Site Plan and Design Review Staff Report and Recommendation

REPORT DATE:	September 26, 2022
HEARING DATE:	October 3, 2022
PROJECT NAME:	Stonewood Apartments
FILE NUMBER:	311-22-000024-PLNG
LAND USE REQUEST:	Site development and design review of a proposed 32-unit multi-family apartment complex.
PROPERTY LOCATION:	Fir Road & Pacific Avenue Washington County Tax Lot 1S305AB00501
APPLICANT:	Matt Newman, NW Engineers
OWNER:	AC Buzz Avery-Stonewood Center LLC.
COMPREHENSIVE PLAN MAP DESIGNATION:	Community Commercial (CC)
ZONING MAP DESIGNATION:	Community Commercial (CC)
APPLICABLE STANDARDS AND CRITERIA:	City of Forest Grove Development Code §17.2.300 et. seq. <i>Design Review</i> §17.2.400 et. seq. <i>Site Development Review</i> §17.3.300 et. seq. <i>Commercial and Mixed-Use Zones</i> §17.7.200 et. seq. <i>Solid Waste and Recycling</i> §17.8.000 et. seq. <i>General Development Standards</i> City of Forest Grove Design Guideline Handbook Focus Area III <i>Multi-Unit Residential Focus Area</i>

REVIEWING STAFF:	Amy Kreimeier (AICP) Senior Planner
RECOMMENDATION:	Staff recommends approval with conditions

Site Plan

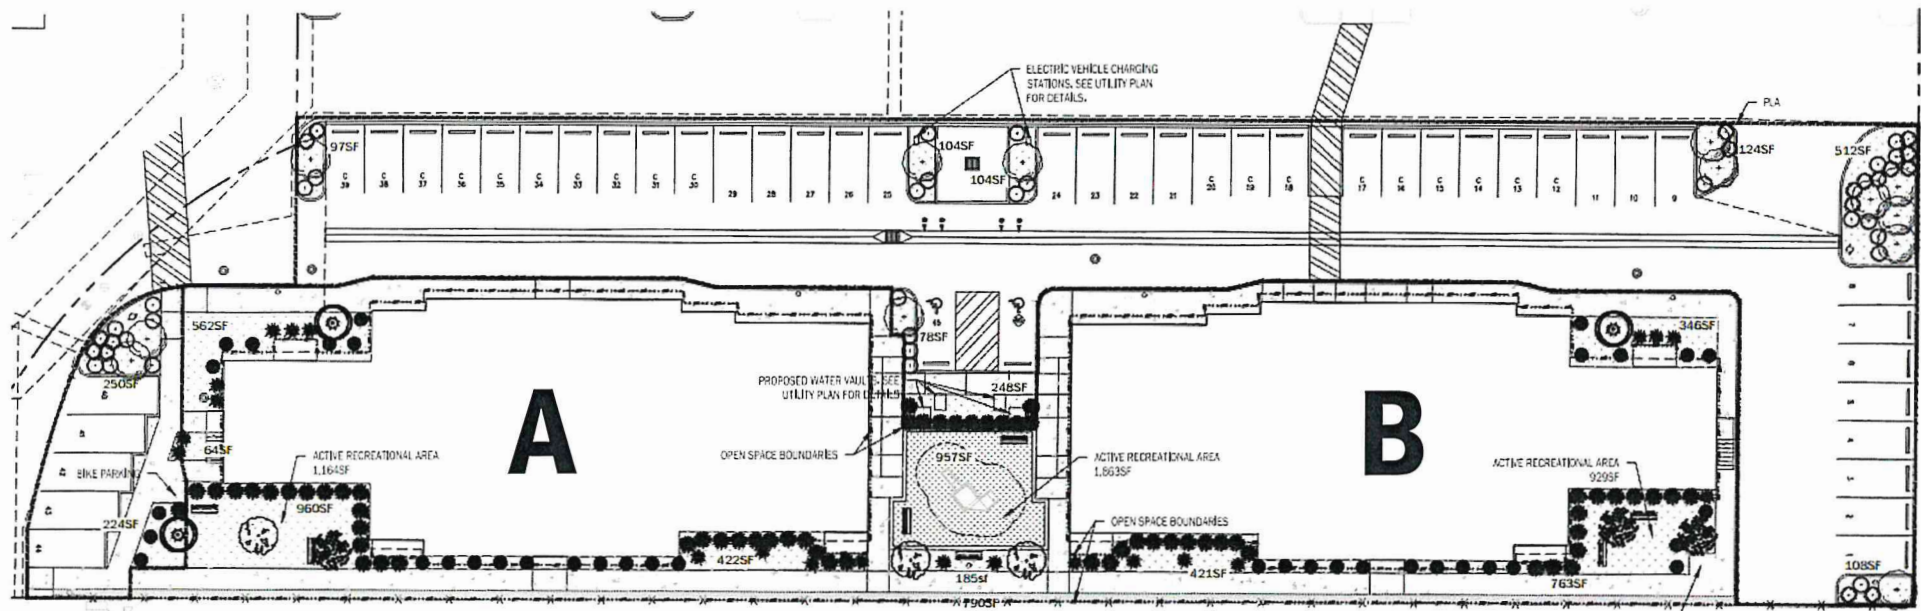
The proposed buildings provide no separation from public pathways in numerous locations. Staff has proposed a **condition** to require a minimum of 3 feet of separation between the dwellings and pathways. This would ensure separation between the dwelling units, including the front door of the exterior accessed ground-floor units, and the public sidewalk, creating distinction between the public and private realm. Compliance with this condition would also reduce the stairwells obstruction into the pedestrian pathway resulting in a design similar to the proposed stairwell on the western edge of the subject site.

Staff also proposes a **condition** to replace the proposed CMU wall with a 6-foot-tall hedge. A hedge is preferable to a CMU wall, which may become an attractive nuisance for graffiti and tagging. A landscaped hedge will provide the same visual and physical buffer between the subject site and the Stonewood Center while softening the visual impact of the development.

11. The 2-foot-wide planting area along the southern property line shall be planted with a mixture of groundcover and shrubs.
12. Replace the proposed CMU wall with a 6-foot-tall landscape hedge.

13. The primary parking area access aisle shall be clearly marked and signed to show one-way direction of traffic flow from west to east.
14. The maximum permitted fence height for residential uses is 6-feet. The proposed chain link fence along the southern edge of the site is limited to a maximum height of 6 feet.
